7315 BALTIMORE AVENUE, TAKOMA PARK

MONTGOMERY COUNTY HISTORIC PRESERVATION COMMISSION
STAFF REPORT

Address:	7315 Baltimore Avenue, Takoma Park	Meeting Date:	8/21/2013
Resource:	Contributing Resource Takoma Park Historic District	Report Date:	8/14/2013
Applicant:	Brian Finlay	Public Notice:	8/7/2013
Review:	HAWP	Tax Credit:	N/A
Case Number:	37/03-13DD	Staff:	Josh Silver
PROPOSAL:	Construction of addition and other alterations

WEST ELEVATION

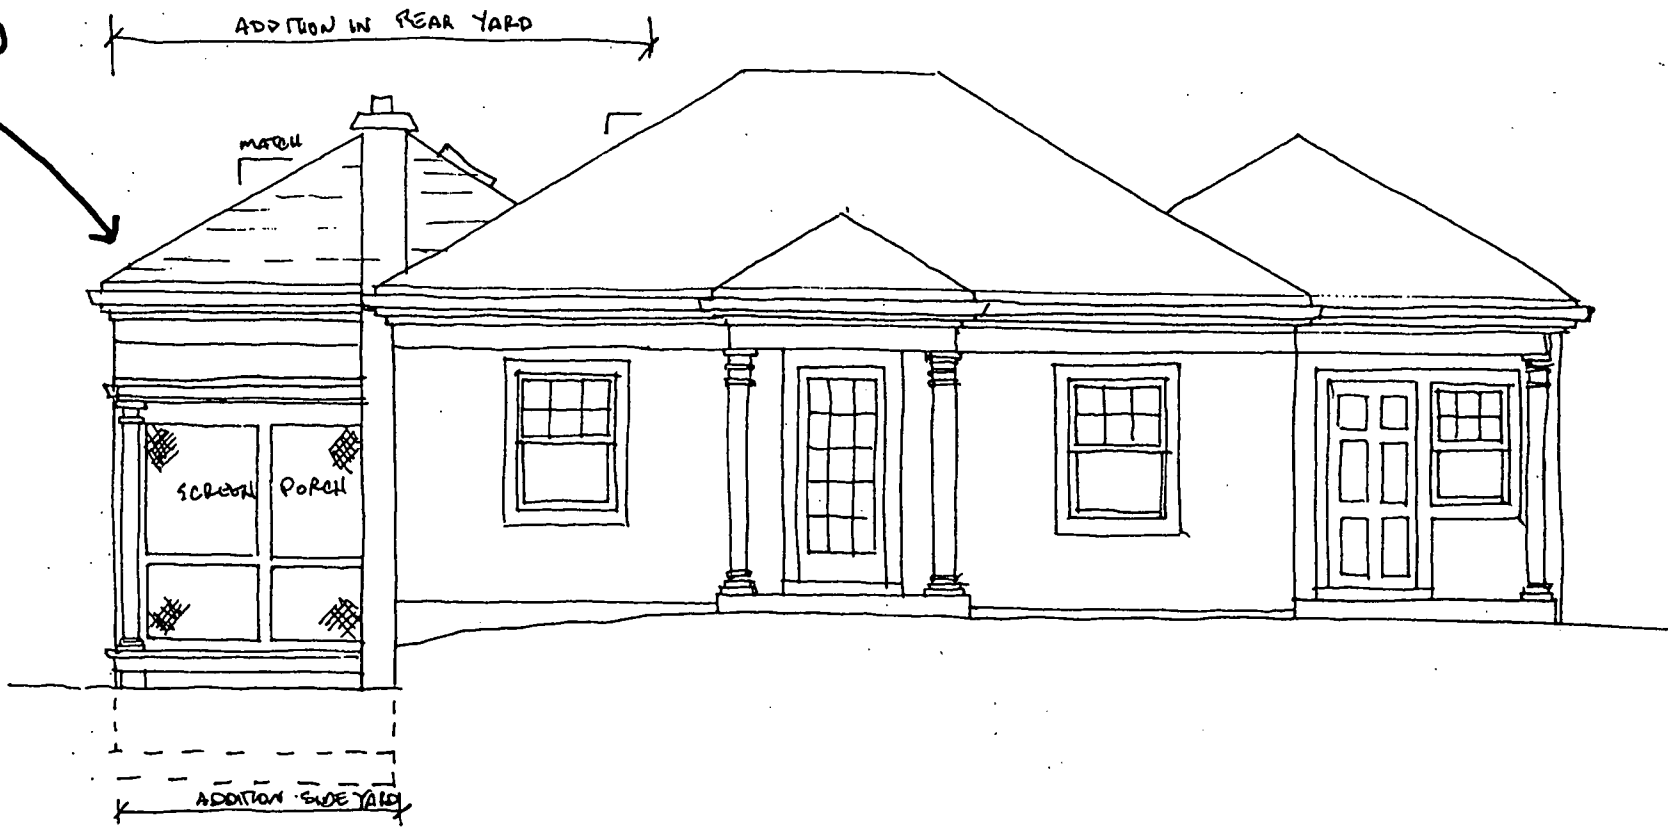
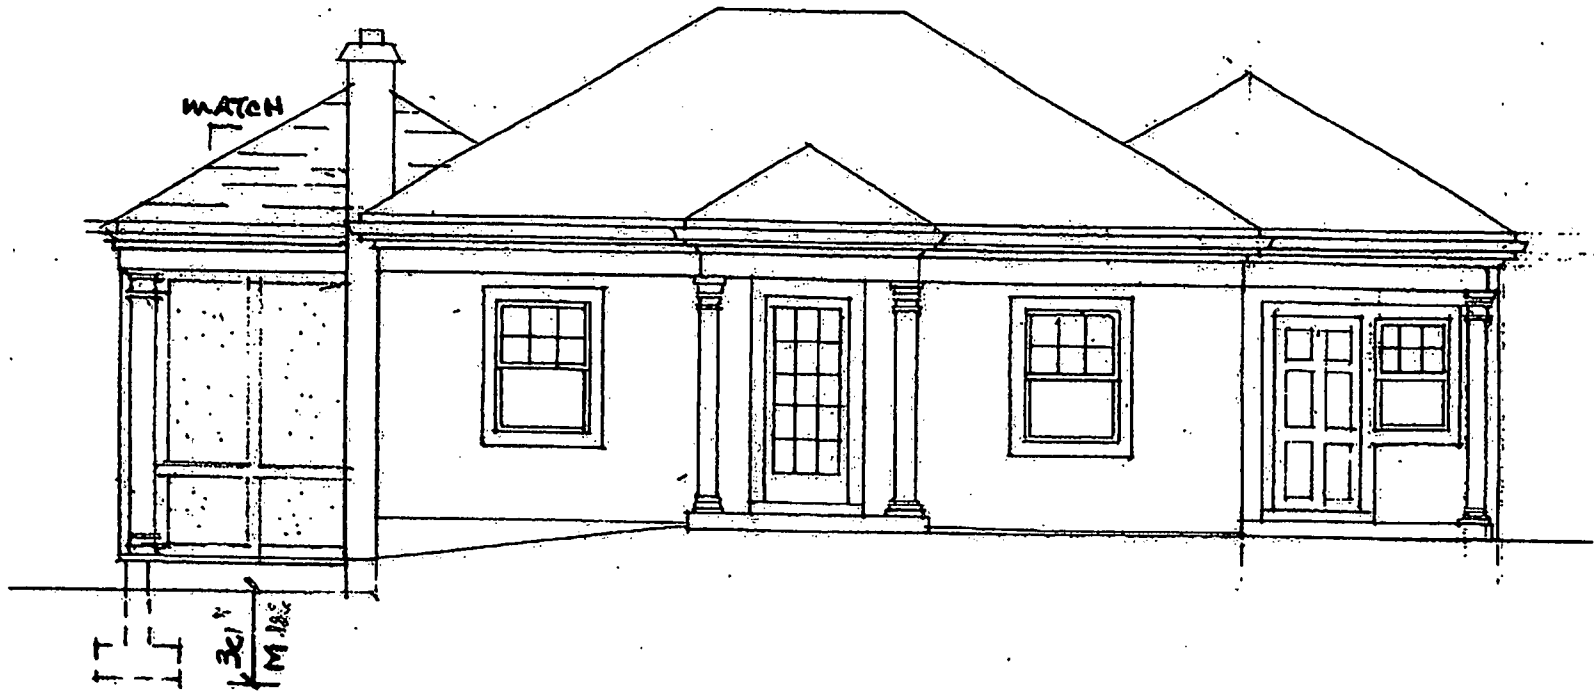
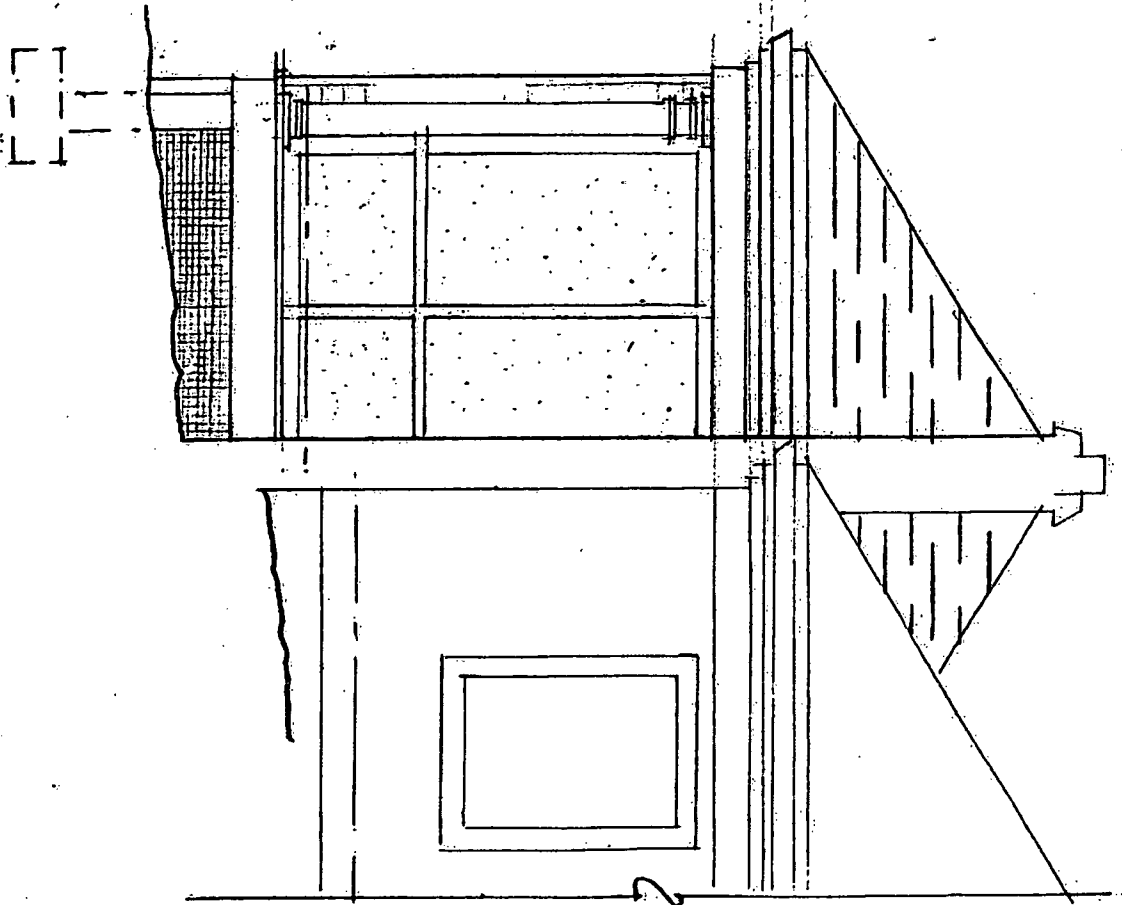
- Raising the front porch column and cornice height of the proposed front porch section was recommended for consistency with the existing front porch columns and non-historic addition on the front facade

As a matter of visibility from the public right-of-way, the revised design includes a higher column and eave height for consistency with the existing non-historic addition at the right and front porch columns.

NORTH ELEVATION

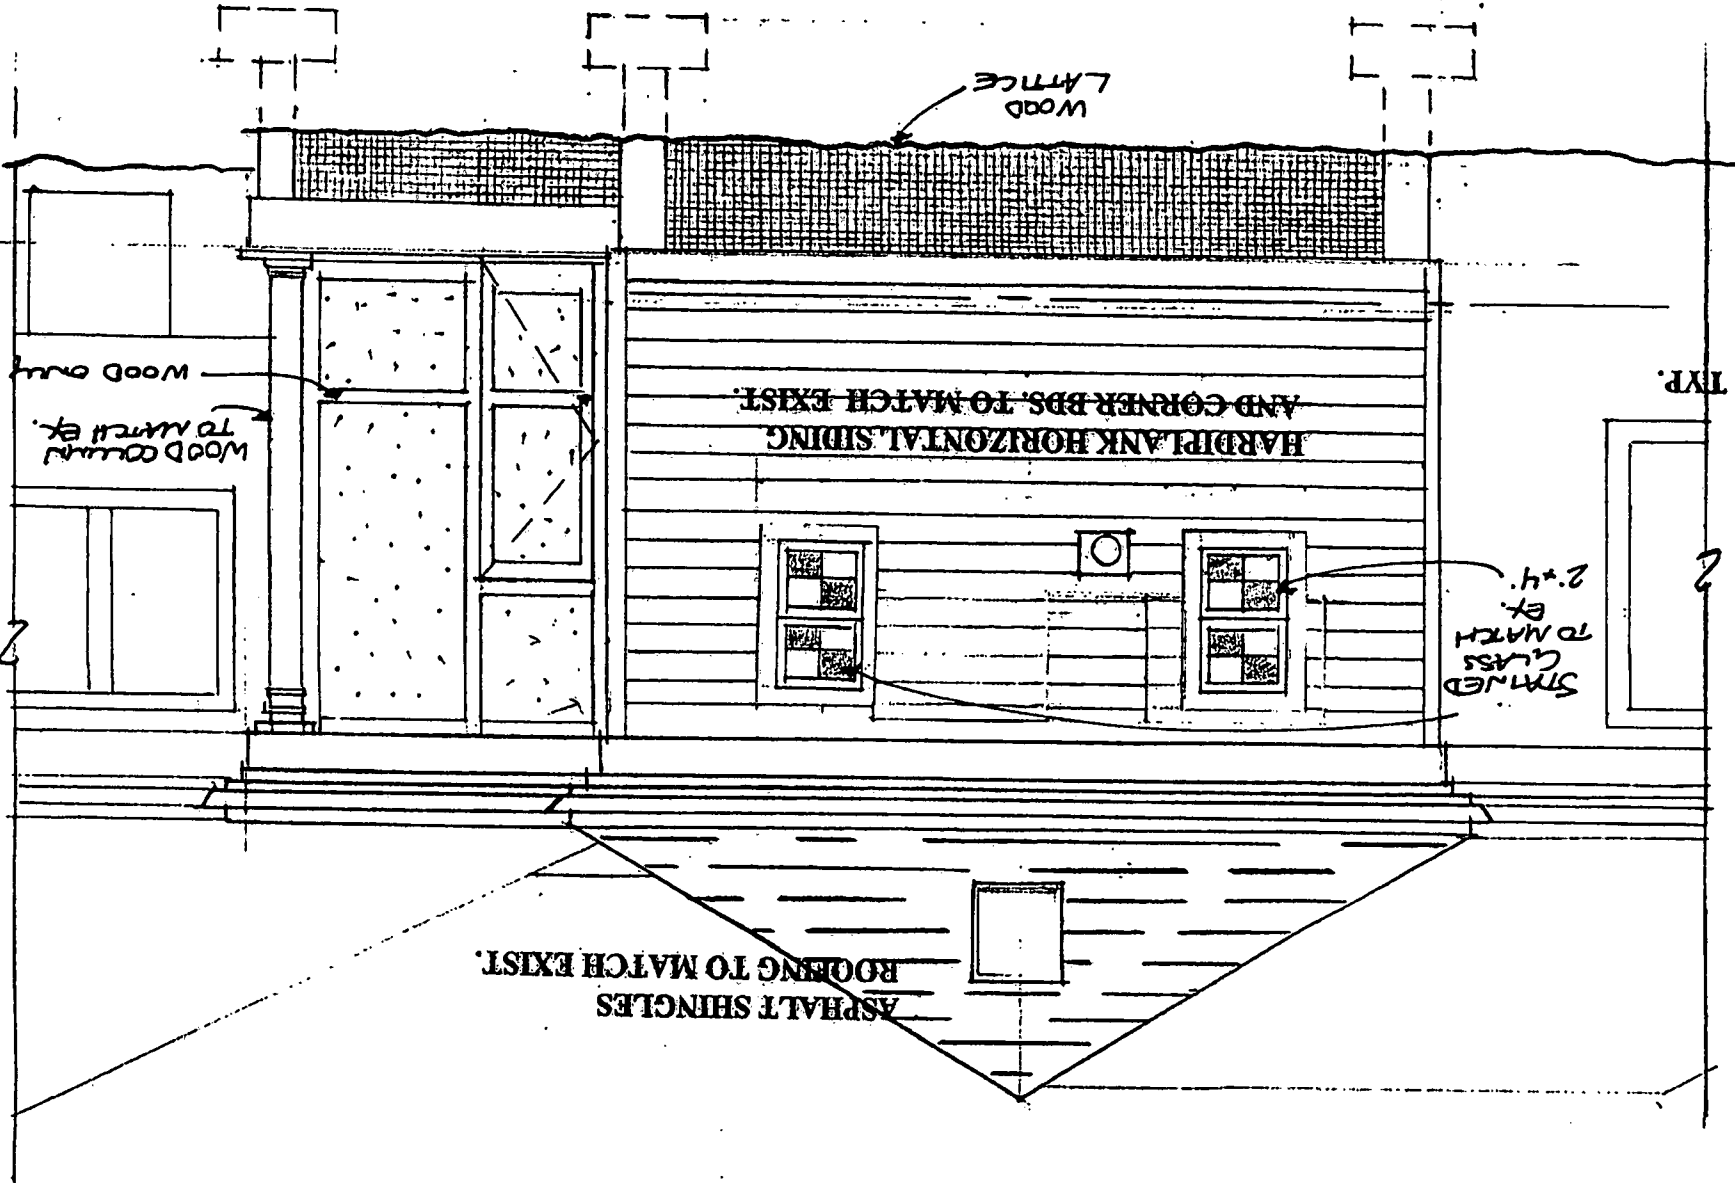
- Further examination of the proposed addition's windows and features was recommended. Specific comments included addressing window proportions and fenestration on the addition's north elevation

The proportion and location of the windows on the north elevation have been revised and are now more in keeping with the fenestration of other elevations. Staff supports the south and east elevation windows as proposed. The window locations, style and size remain generally consistent with those reviewed by the HPC at the May 2013 preliminary consultation hearing.
